# THE RETREAT AT WOLF CREEK CONDOMINIUMS

## CONSTRUCTION DOCUMENTS EDEN, WEBER , UTAH

THE RETREAT AT WOLF CREEK CONDOMINIUMS  
CONSTRUCTION DOCUMENTS

SITE PLAN  
 THE RETREAT AT WOLF CREEK CONDOMINIUMS  
 TOWNHOMES  
 EDEN, WEBER, UTAH

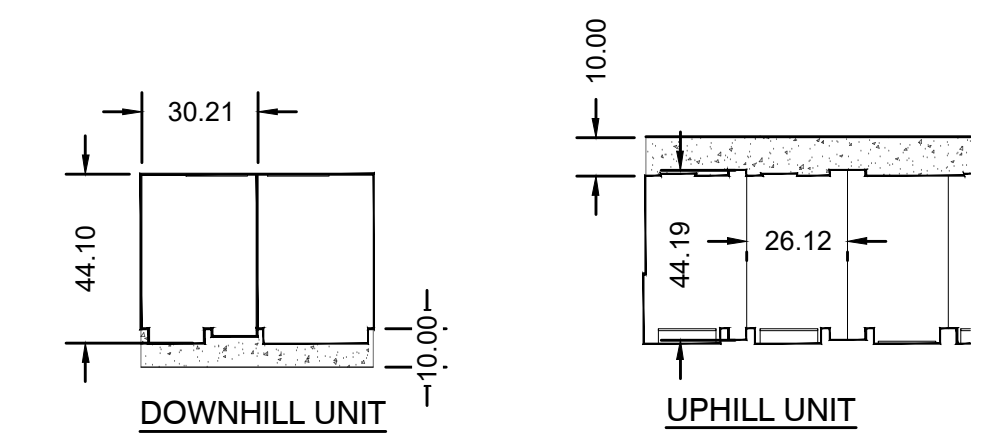
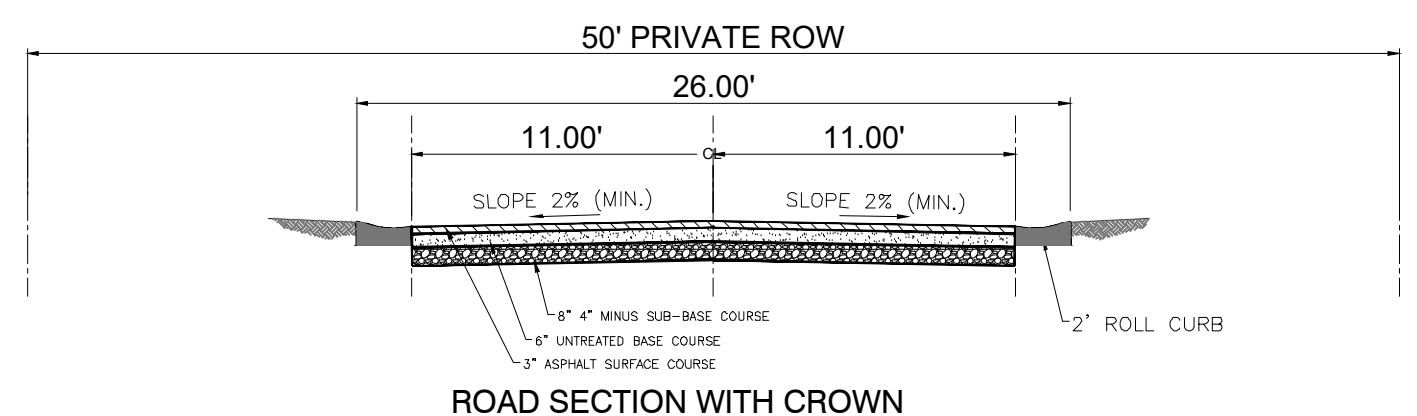
Rock Walls will need to be engineered w/ stamped plans

Is this drainage swale existing or proposed?

PRELIMINARY DRAINAGE PLAN  
THE RETREAT AT WOLF CREEK CONDOMINIUMS  
TOWNHOMES  
EDEN, WEBER, UTAH

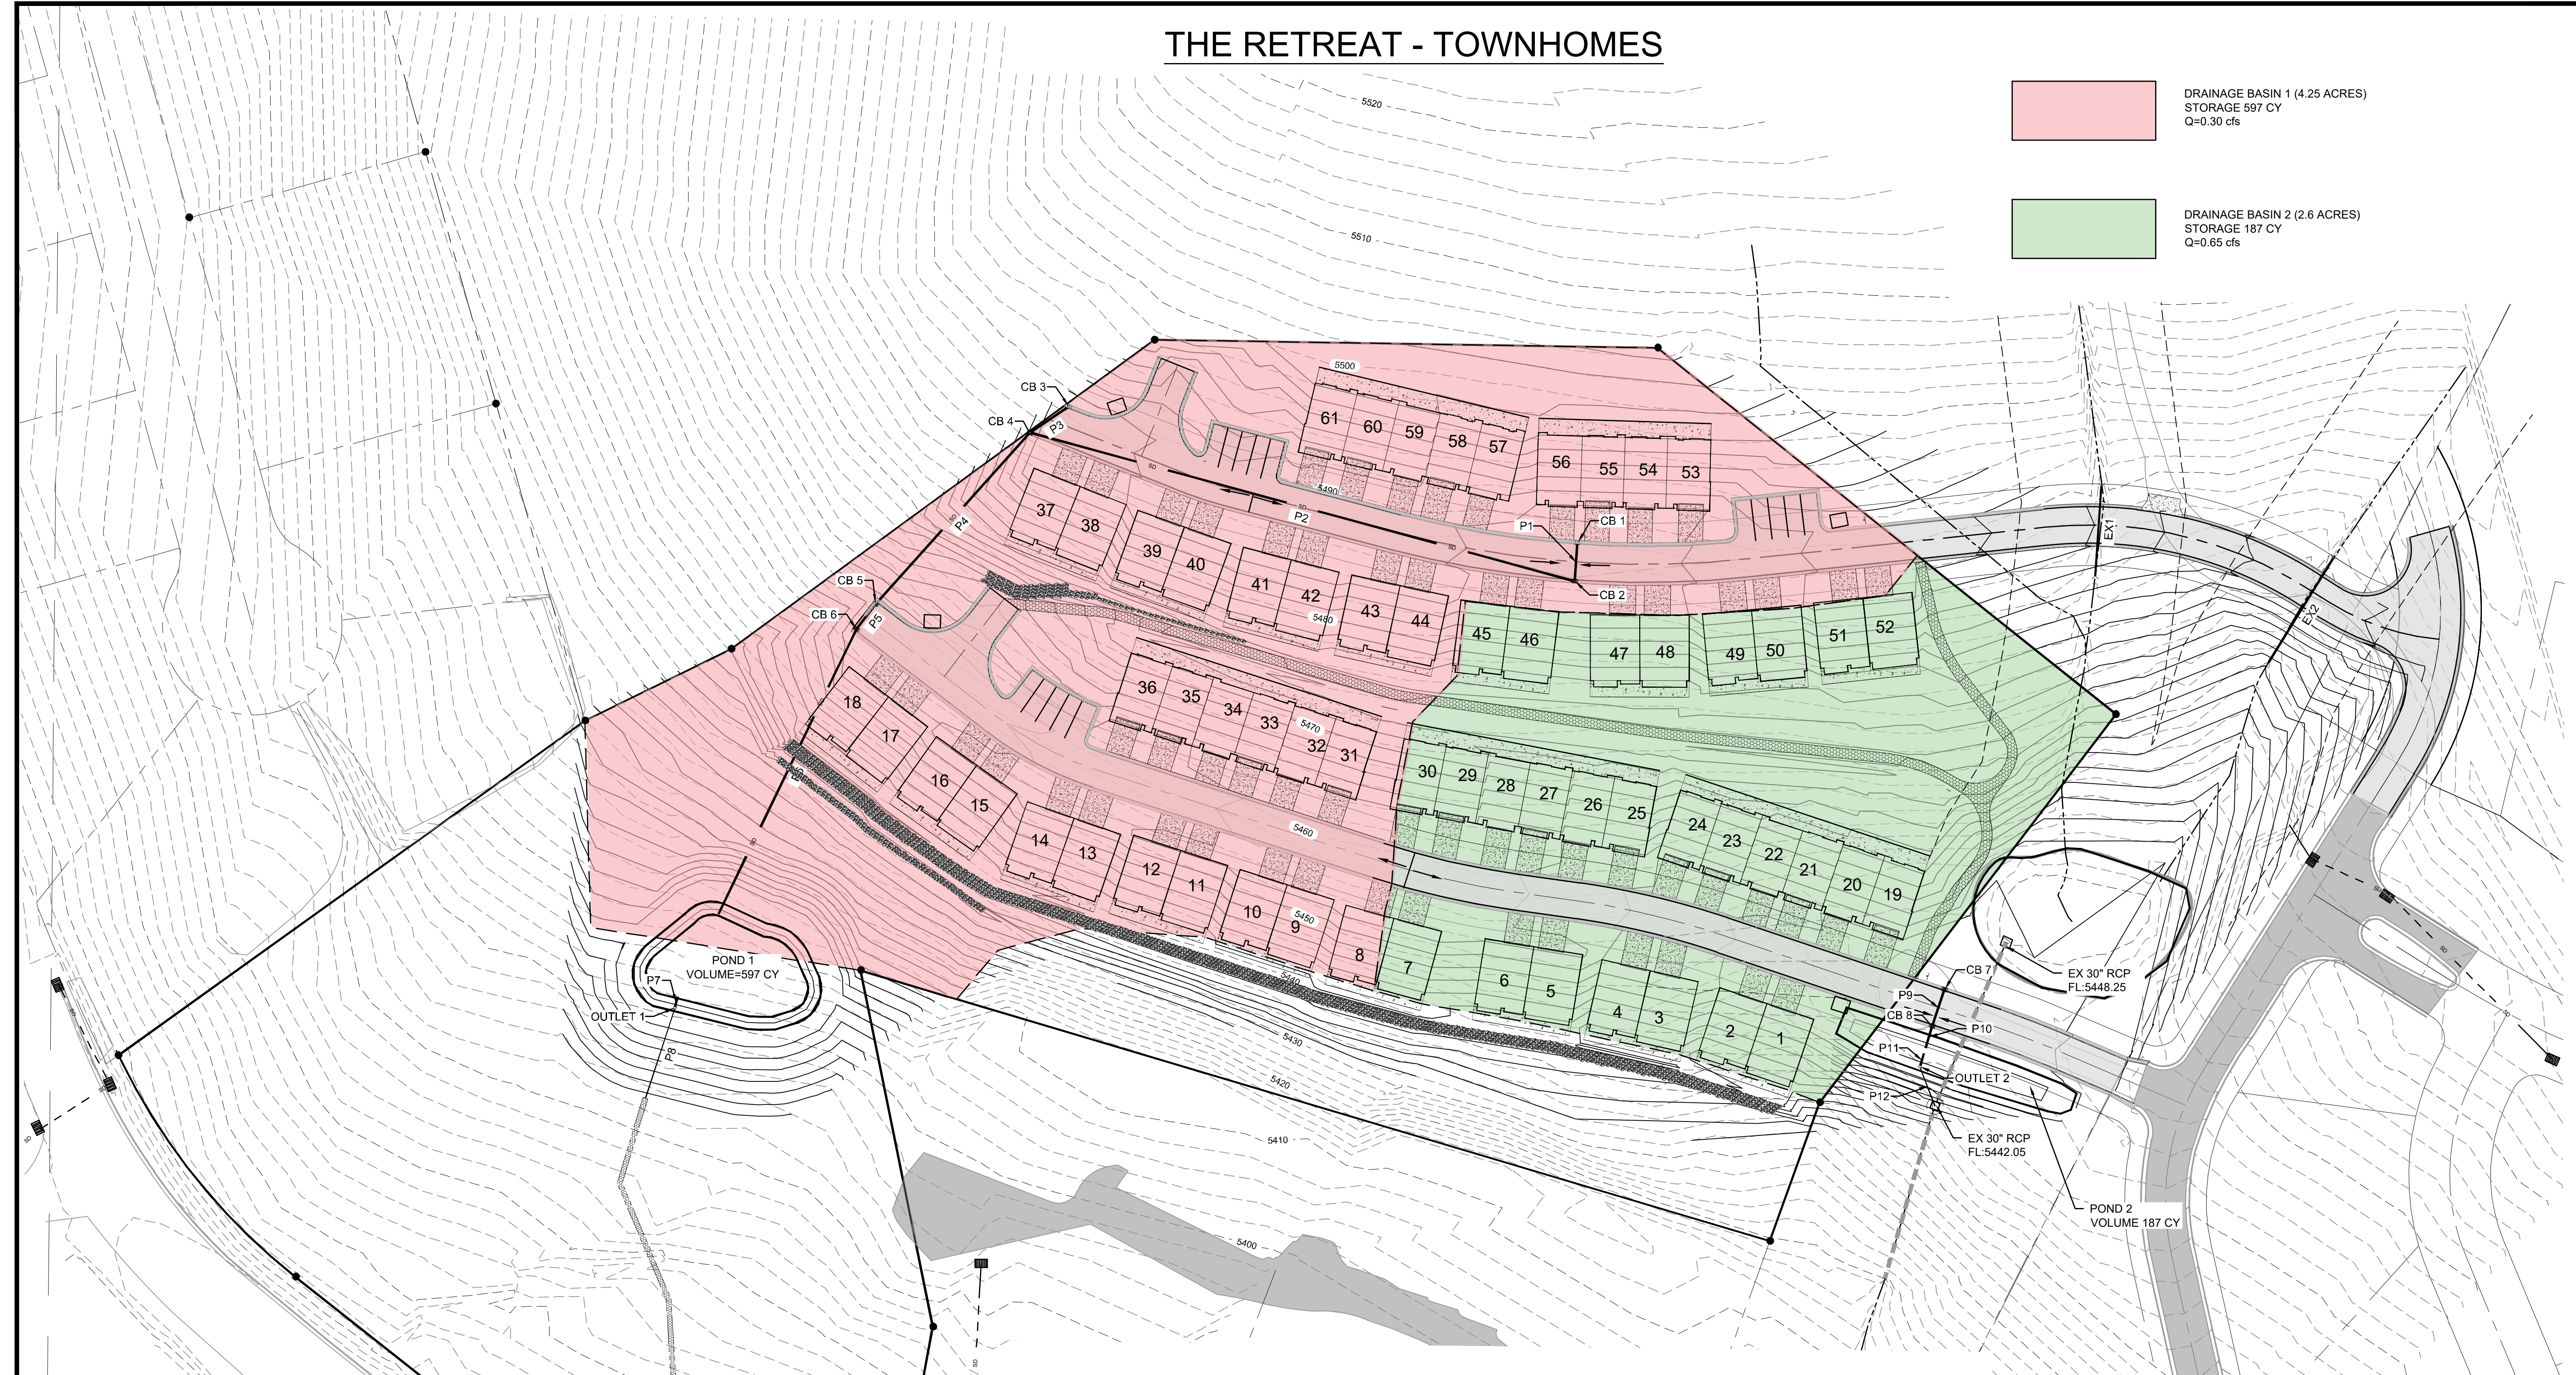
Check elevations of FL for CB 5

PRELIMINARY UTILITY PLAN  
 THE RETREAT AT WOLF CREEK CONDOMINIUMS  
 TOWN HOMES  
 EDEN, WEBER, UTAH

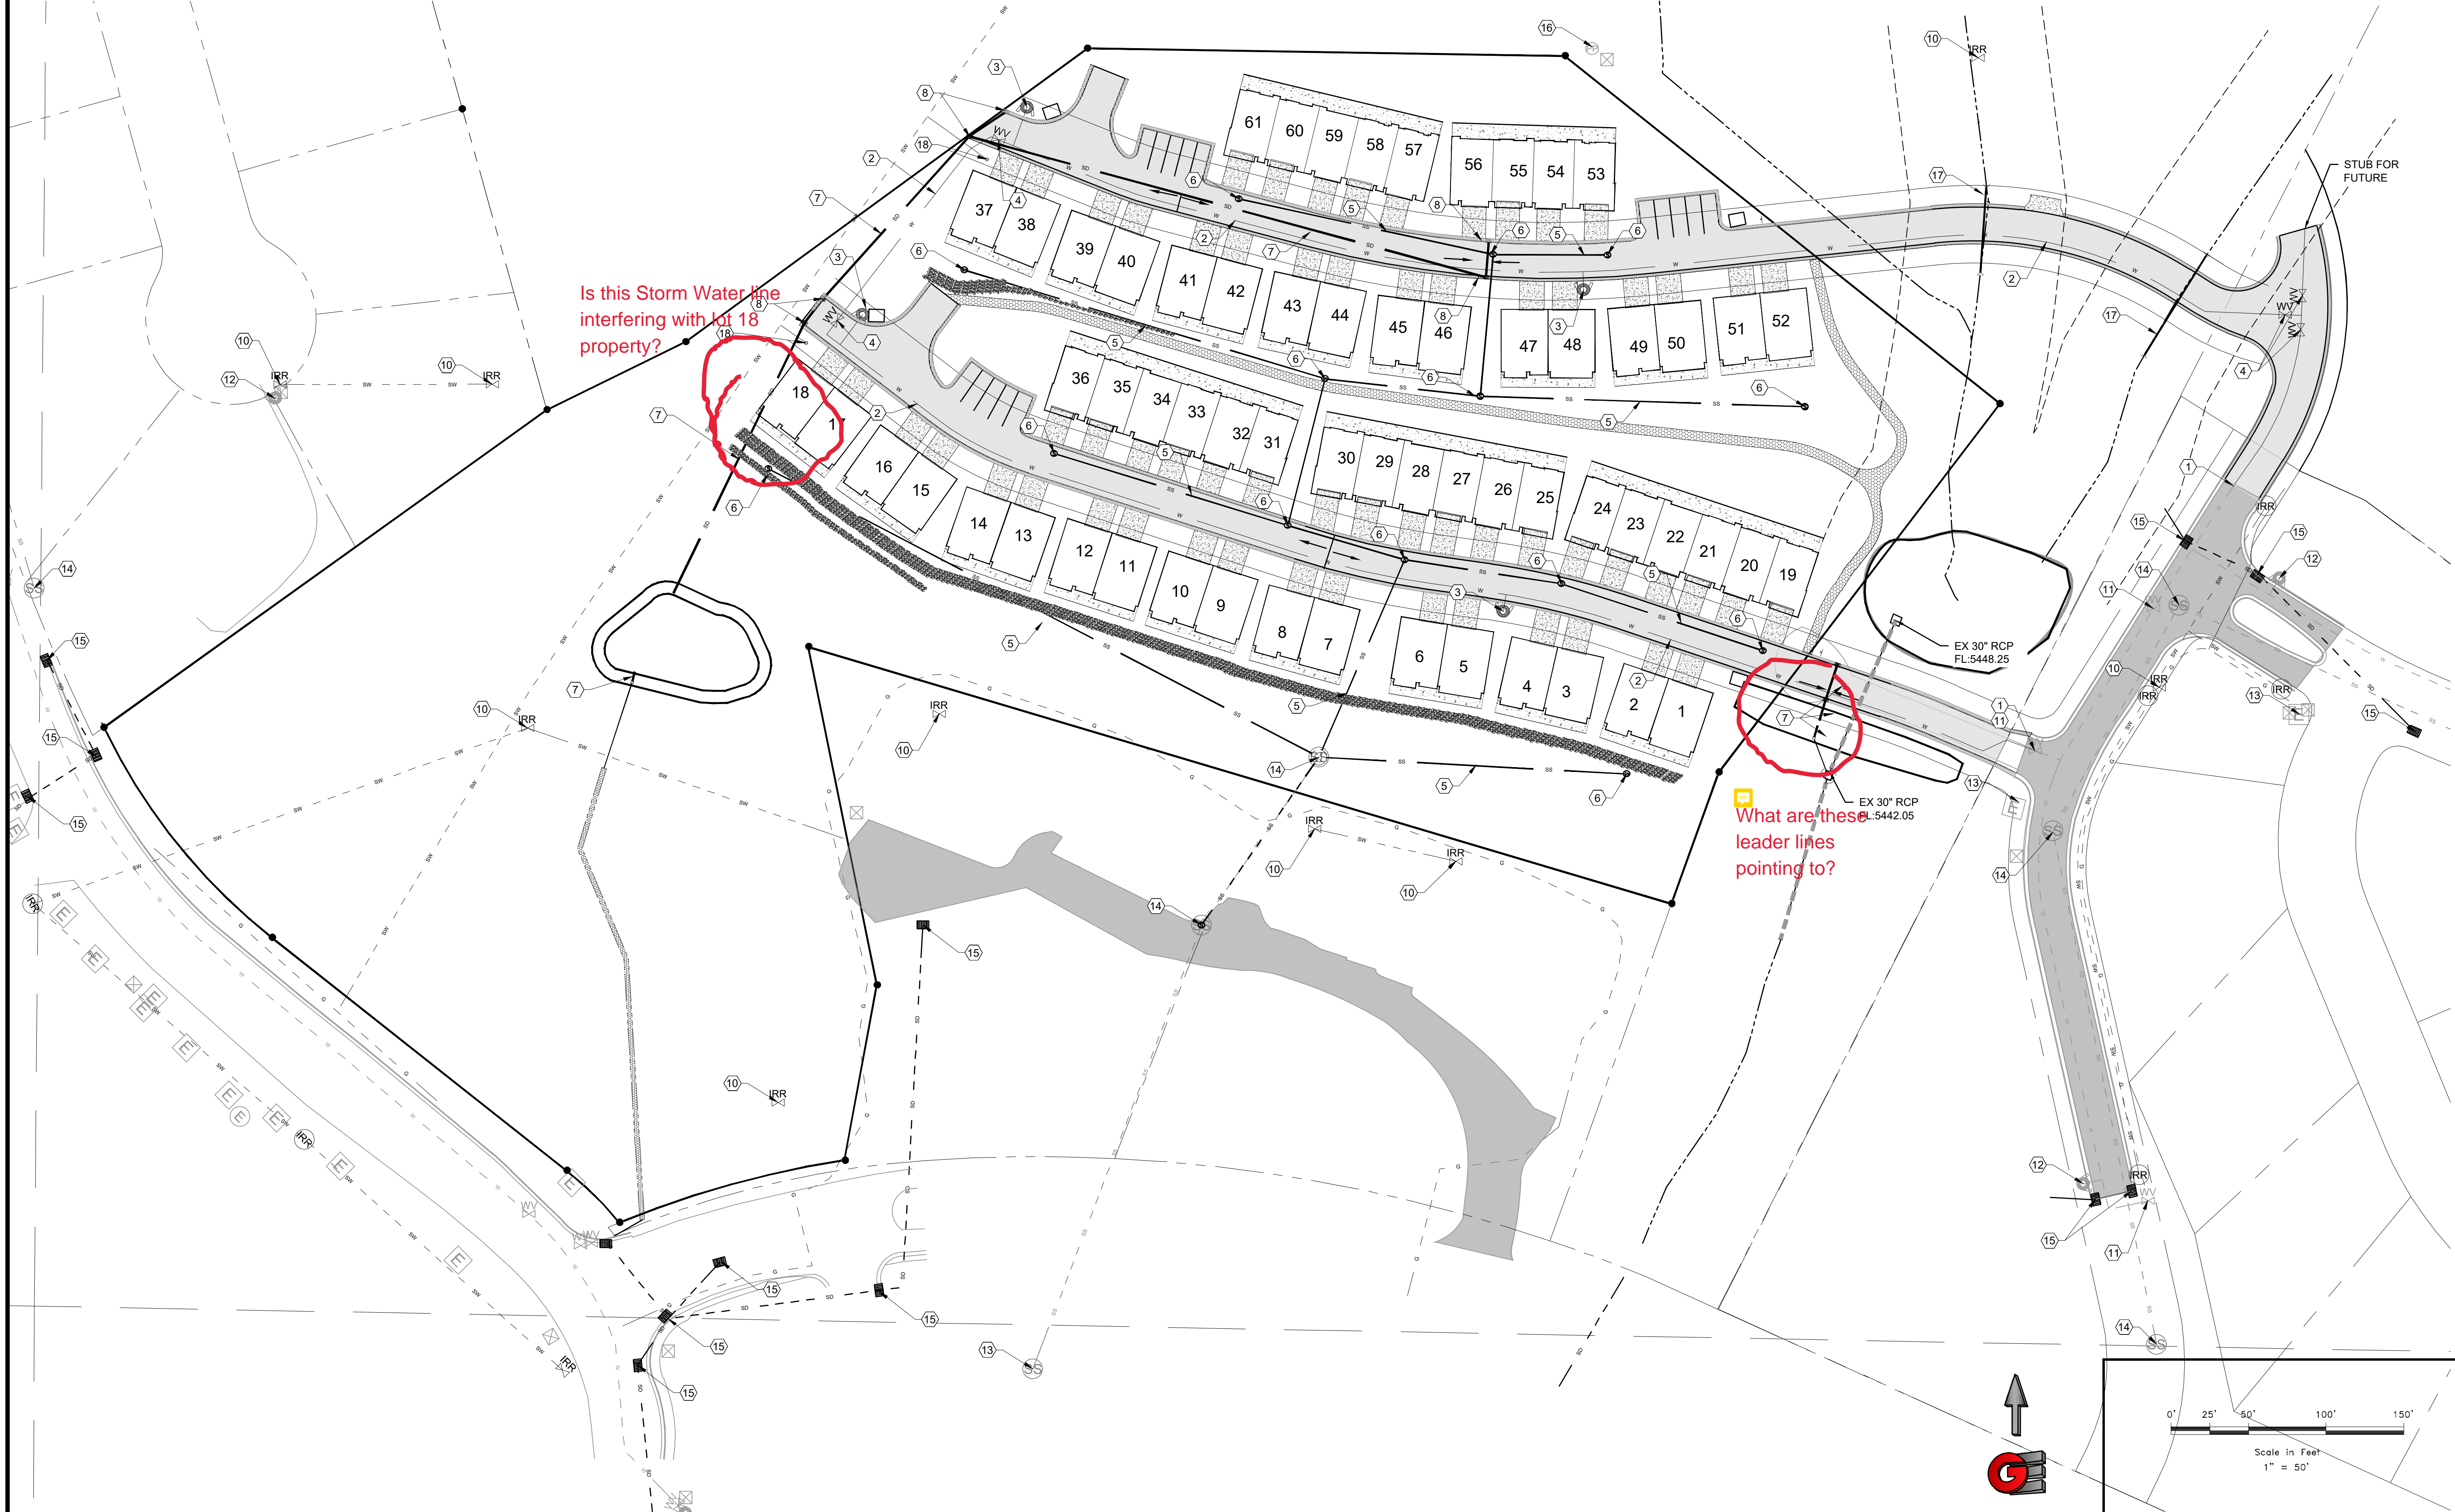
Is this Storm Water line interfering with lot 18 property?

What are these leader lines pointing to?

PLAN AND PROFILE SEWER 1

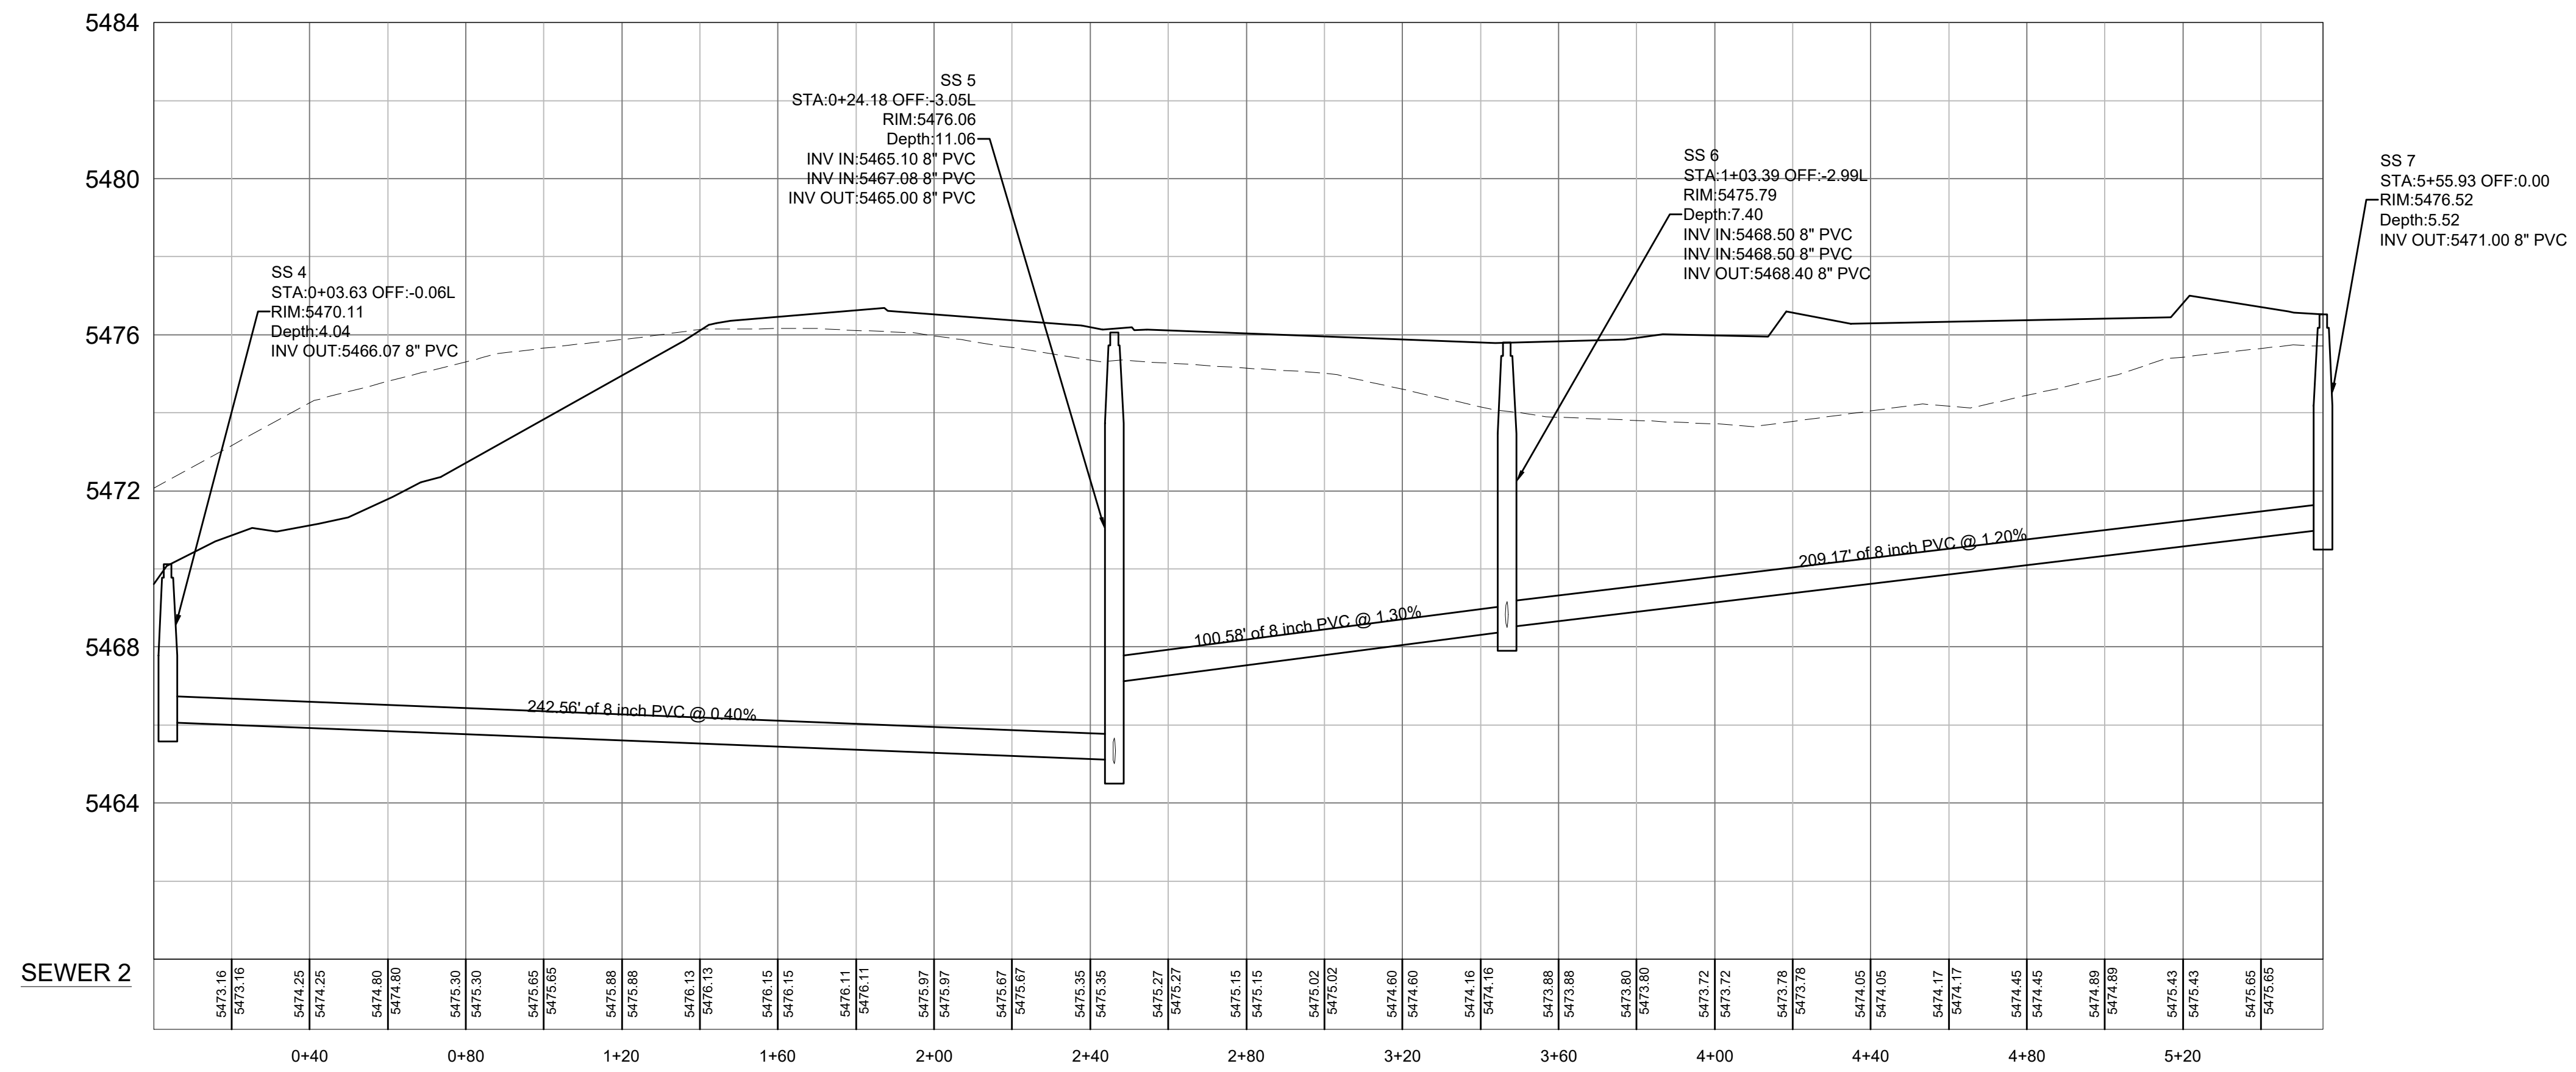
Will SS 4 be exposed on the down slope side?  
check elevation.
